Access Compliance Report Public Rights-of-Way (Curb Ramps)

Main Street: SILVERWOOD_DR Cross Street: FOSTER_RD Location: S

ADA ID: RPAT211202120617 Ramp Type: Type 1 - Perpendicular Diagonal Initial Pass/Fail: Pass Overall Compliance: No Severity Score: 0

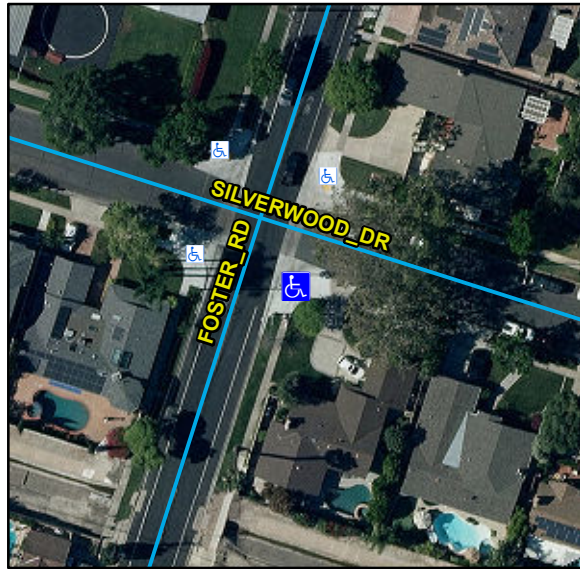
R304.2.2, R304.5.3, R302.7, STD 1115

Yes	Ramp Inside Crosswalk 1	Yes	Yes	Ramp Inside Crosswalk 2	N/A
	Crossing 1 Slope (%)	0.8		Crossing 2 Slope (%)	3.5
	Crossing 1 Cross Slope (%)	1.3		Crossing 2 Cross Slope (%)	0.6
No	Gutter Ponding	Yes	No	Curb Slope	9.8
Yes	Gutter Lip Height (in)	0		Road Run Slope (%)	1.1
Yes	Gutter Run Slope (%)	2.2		Road Cross Slope (%)	0.7
No	Gutter Cross Slope (%)	2.1			
Yes	Overall Surface Condition: Acceptable		Yes	Perp Joint Present	Yes
	Cross Gutter Present?	Yes		Spandrel Present?	Yes
	Replace Cross Gutter?	No		Replace Spandrel?	No

Remove & Replace Curb Ramp With Two New Directional Ramps or Equivalent. Remove & Replace Gutter.
